L. CENTER CLASSROOM ENTRIES & PARTITIONS PROJECT
CHESTERTON, INDIANA
gerometta & kinel architects, inc.

CLASSROOM MECH./ELECTRICAL REVISIONS
91-ME-04 B03, 04 YES, YES

REVISED LIGHTING PLAN
YOST ELEM. NTARY CLASSROOMS 203A/203B 1/8"=1'-0"

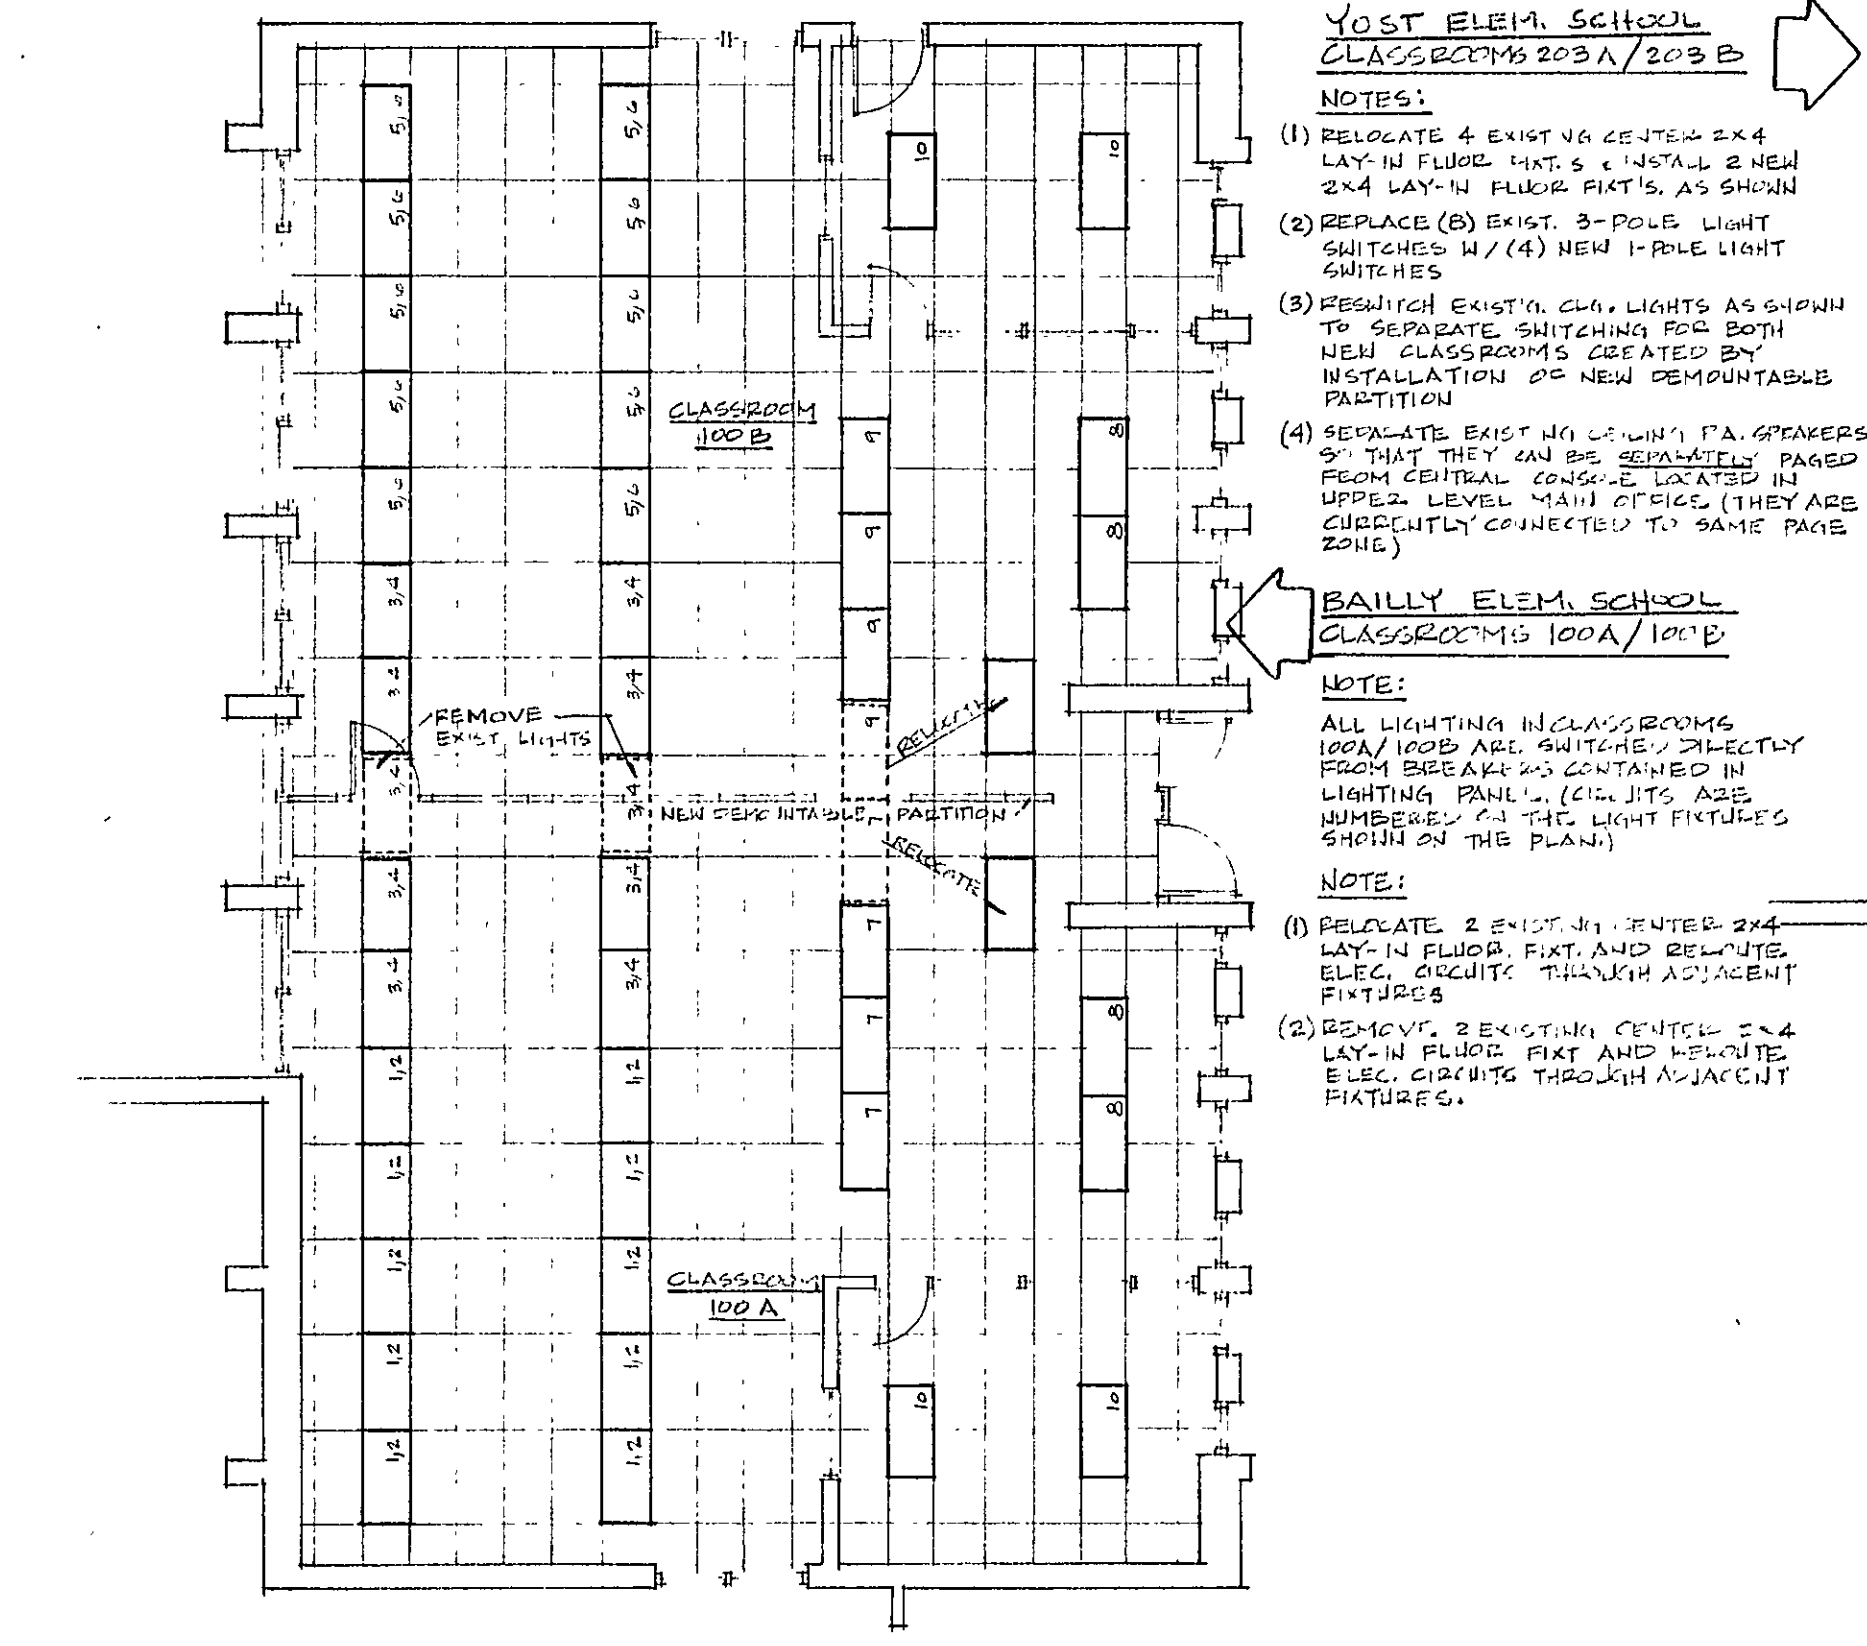
- RELOCATE 4 EXIST. 2x4 LAY-IN FLUOR. FIXT. & INSTALL 2 NEW 2x4 LAY-IN FLUOR. FIXT. AS SHOWN
- REPLACE (8) EXIST. 3-POLE LIGHT SWITCHES W/ (4) NEW 1-POLE LIGHT SWITCHES
- RELOCATE EXIST. CEN. LIGHTS AS SHOWN TO SEPARATE SWITCHING FOR BOTH NEW CLASSROOMS CREATED BY INSTALLATION OF NEW DEMOUNTABLE PARTITION
- SEPARATE EXIST. W/ LAY-IN P.A. SPEAKERS SO THAT THEY CAN BE RELATIVELY PAGED FROM CENTRAL CONSOLE LOCATED IN UPPER LEVEL MAIN OFFICE (THEY ARE CURRENTLY CONNECTED TO SAME PAGE 2016)

REVISED LIGHTING PLAN
BAILLY ELEMENTARY CLASSROOMS 100A/100B 1/8"=1'-0"

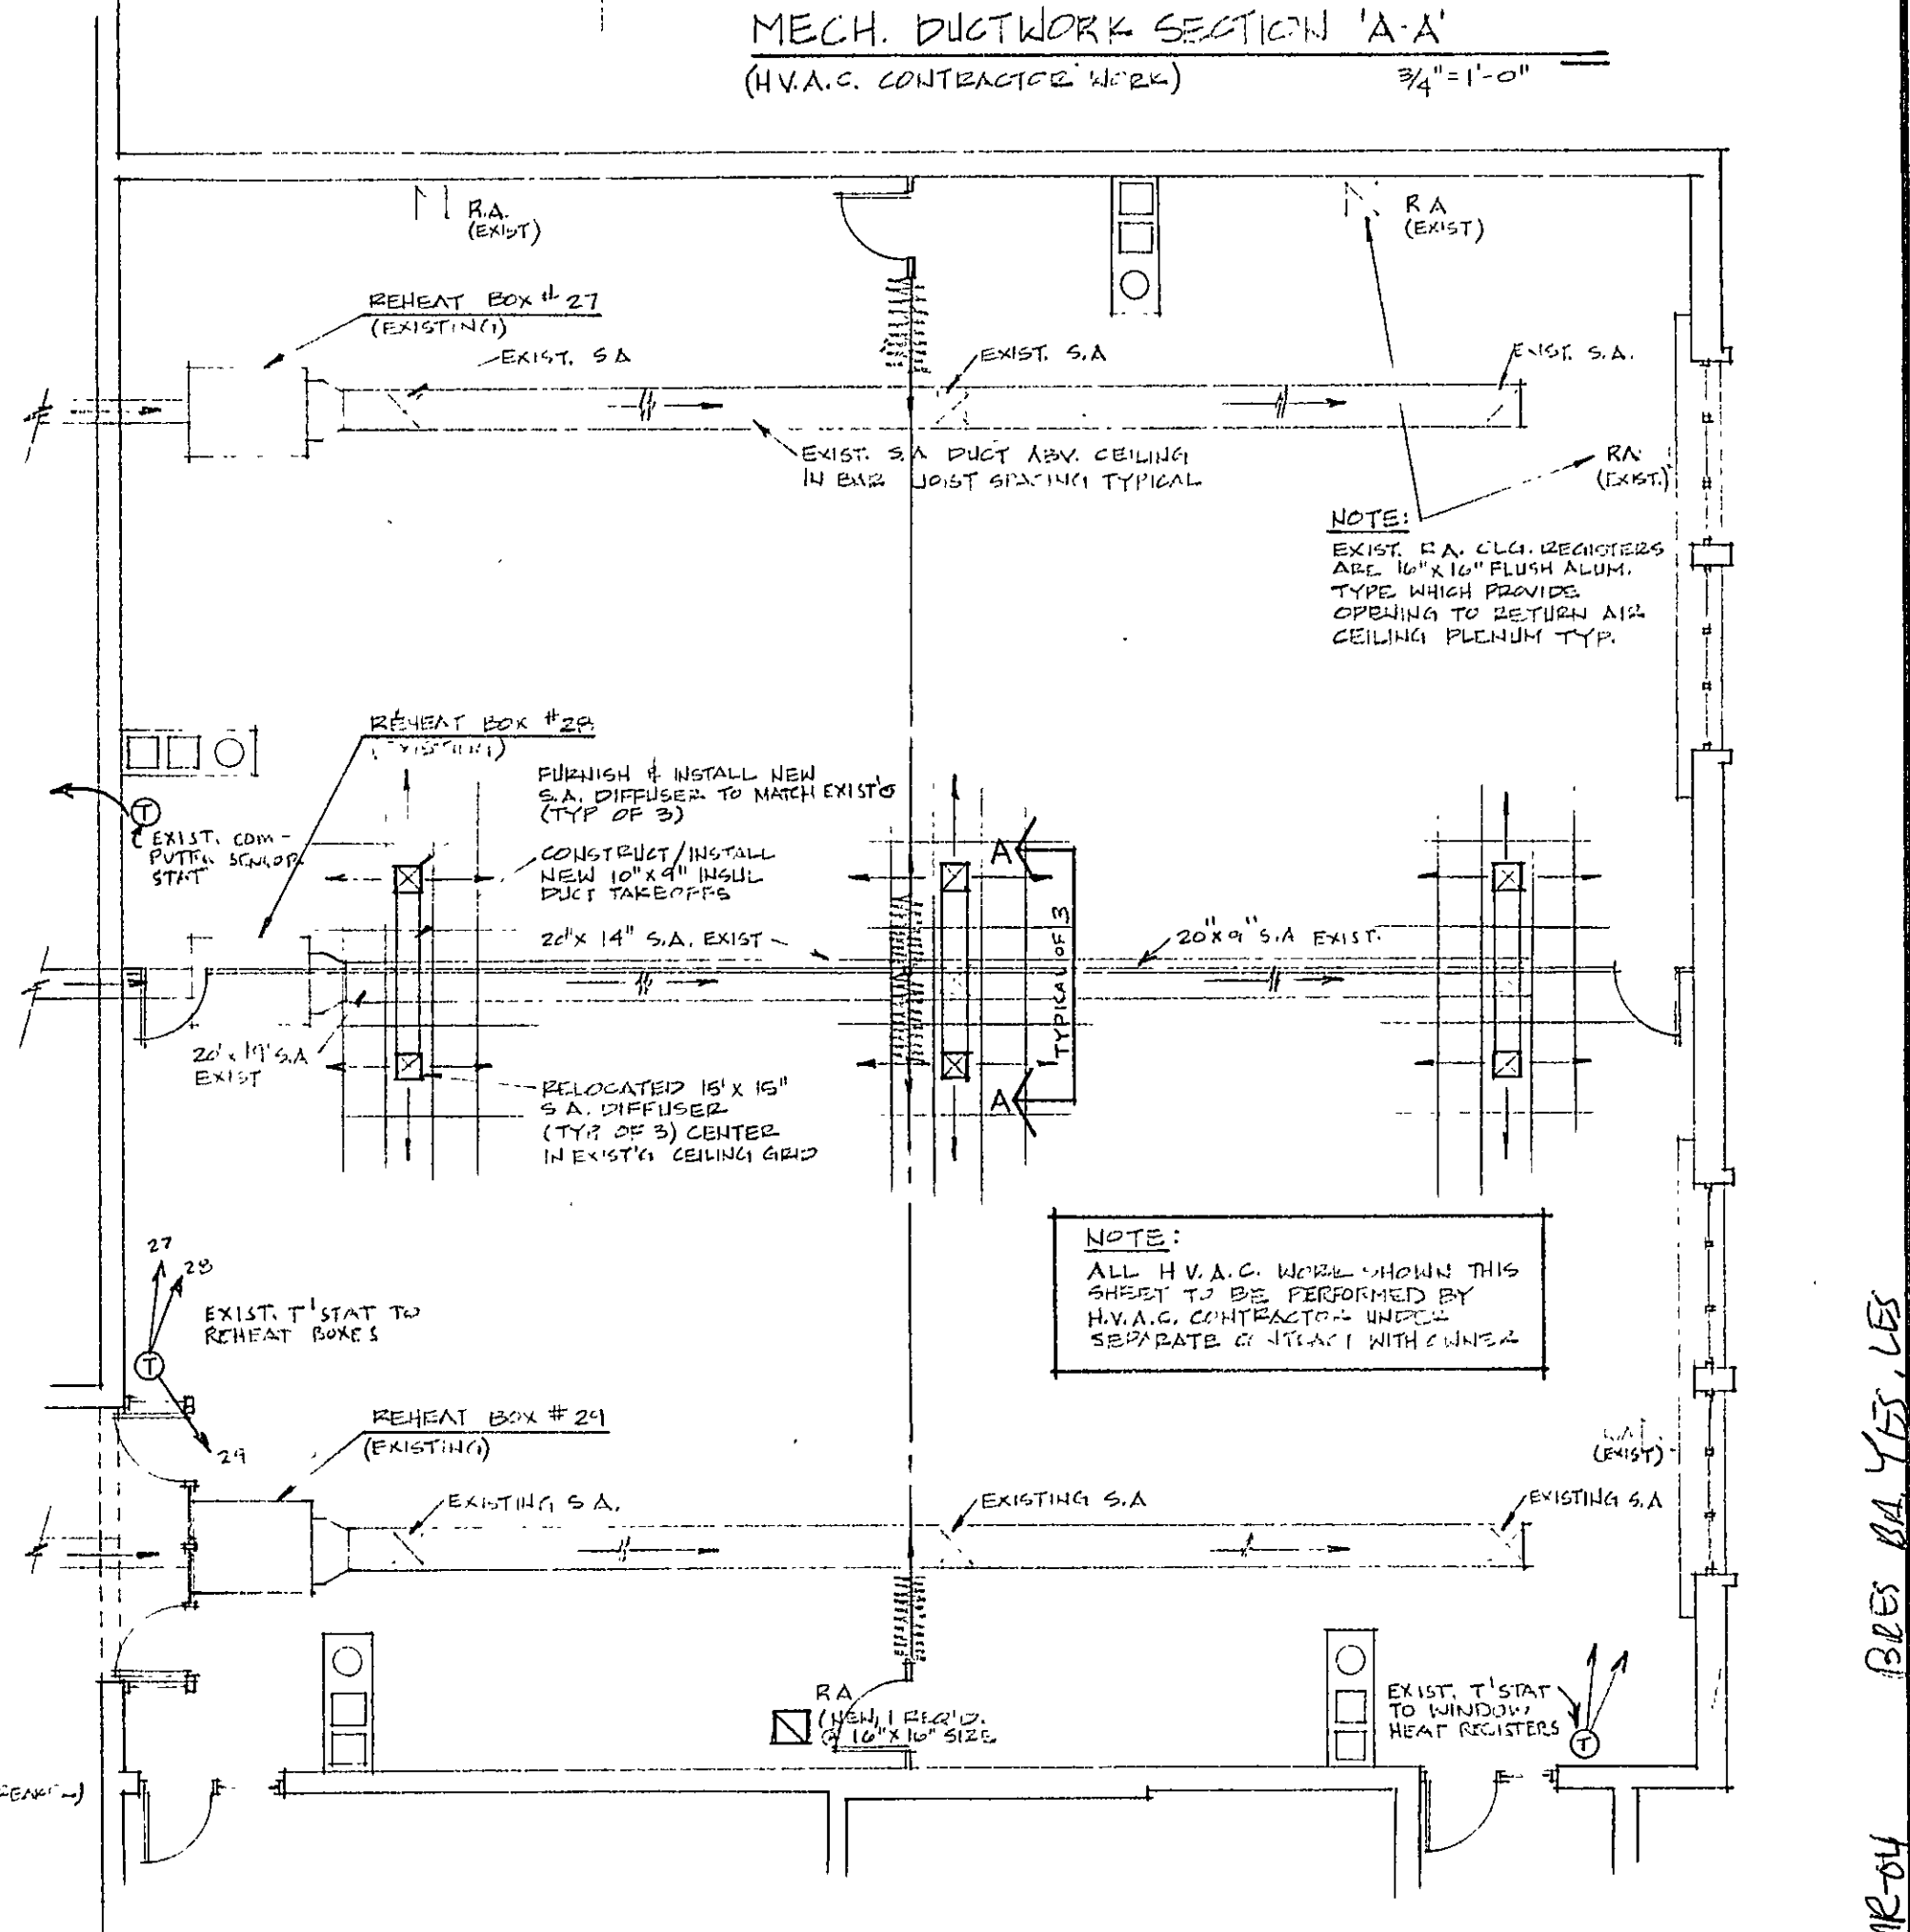
ALL LIGHTING IN CLASSROOMS 100A/100B ARE SWITCHED DIRECTLY FROM BREAKERS CONTAINED IN LIGHTING PANEL. (CIRCUITS ARE NUMBERED ON THE LIGHT FIXTURES SHOWN ON THE PLAN)

- RELOCATE 2 EXIST. 2x4 LAY-IN FLUOR. FIXT. AND RELocate ELEC. CIRCUITS THROUGH ADJACENT PARTITION
- RELOCATE 2 EXIST. CEN. 2x4 LAY-IN FLUOR. FIXT. AND RELocate ELEC. CIRCUITS THROUGH ADJACENT PARTITION

- Lighting/Switching modifications to Special Ed. Classroom 100A/100B as shown on Bailly Lighting Plan this sheet.

REVISED CEILING/LIGHTING PLAN
BRUMMITT ELEMENTARY LEARNING CENTER #3 1/8"=1'-0"

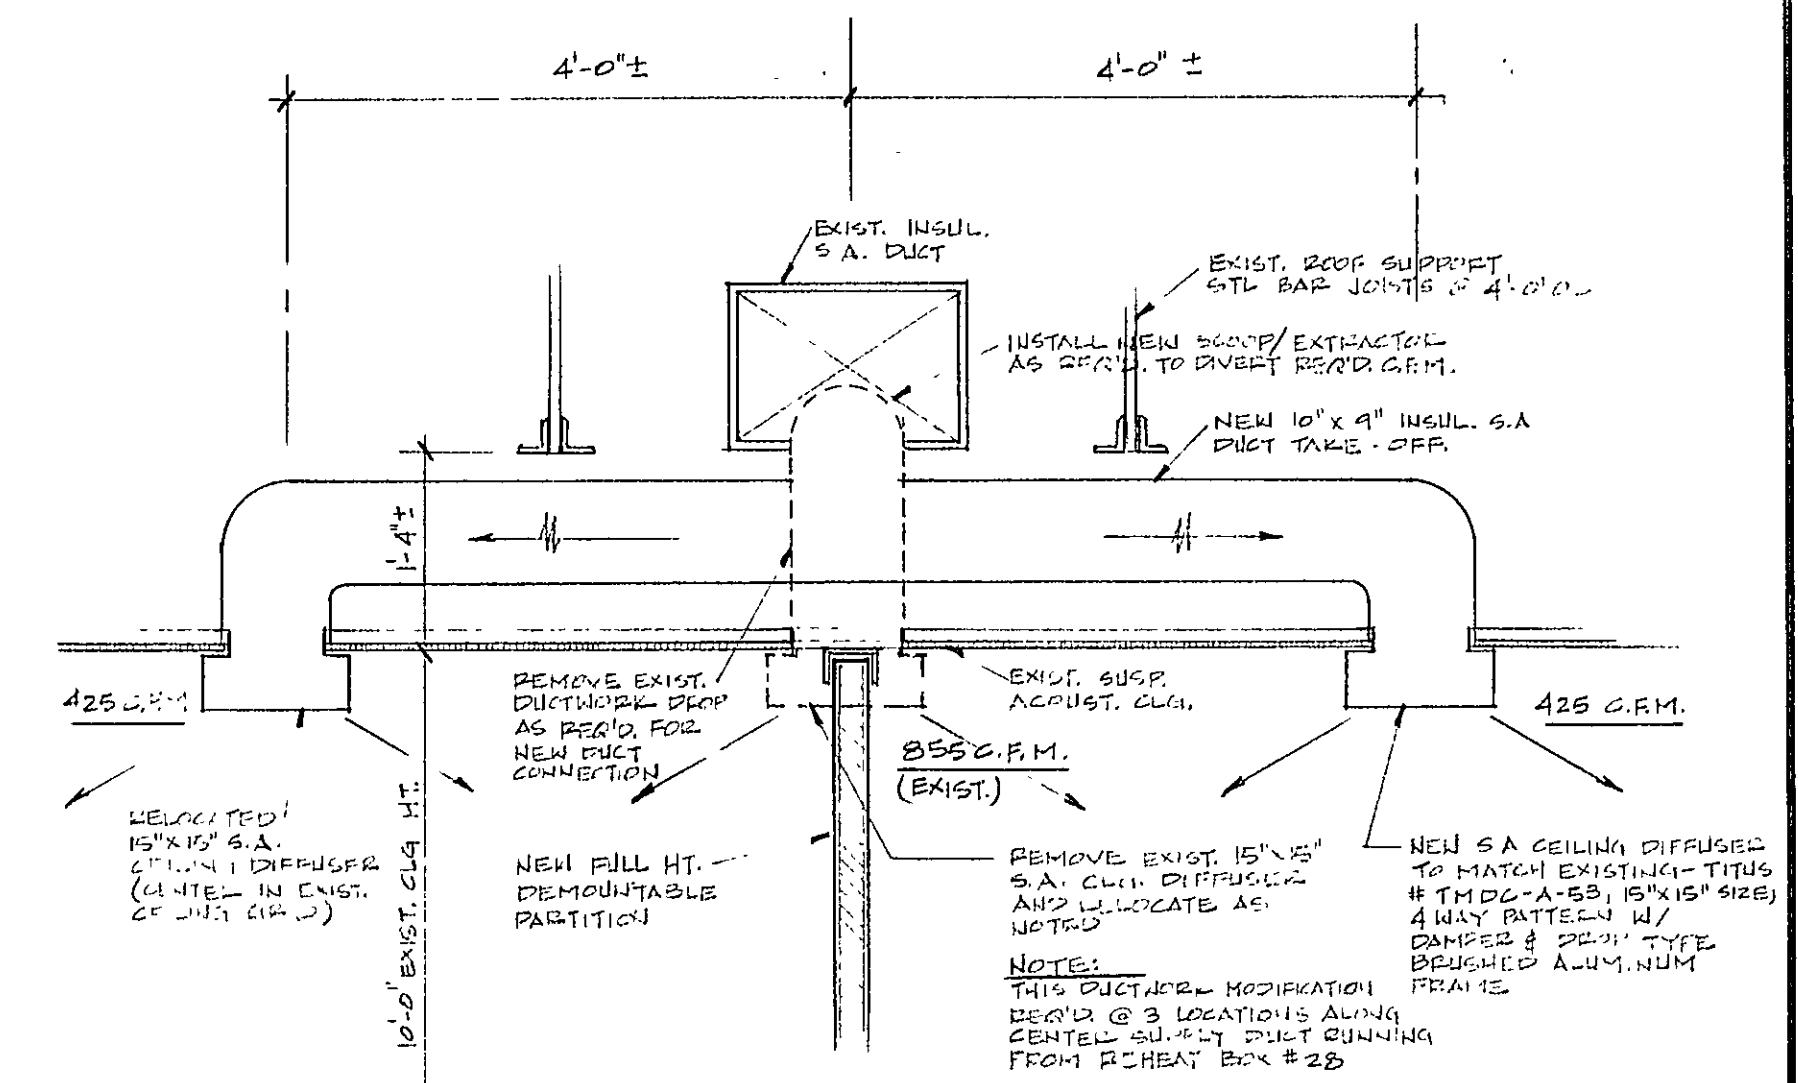
- Lighting/Emergency/switching/Clock modifications to Learning Center #3 as shown on Brummitt Lighting Plan this sheet.
- New Power Feed for electrification of new demountable partitions in Learning Center #3 as shown on Brummitt Power Plan this sheet.
- New Power Feed for electrification of demountable partition in Kindergarten - See Drwg. Sht. A-1 for location. (Single circuit feed from existing nearby power panel located in the Janitor/Utility Room to the West; similar to Learning Center #3 application, but only one circuit).
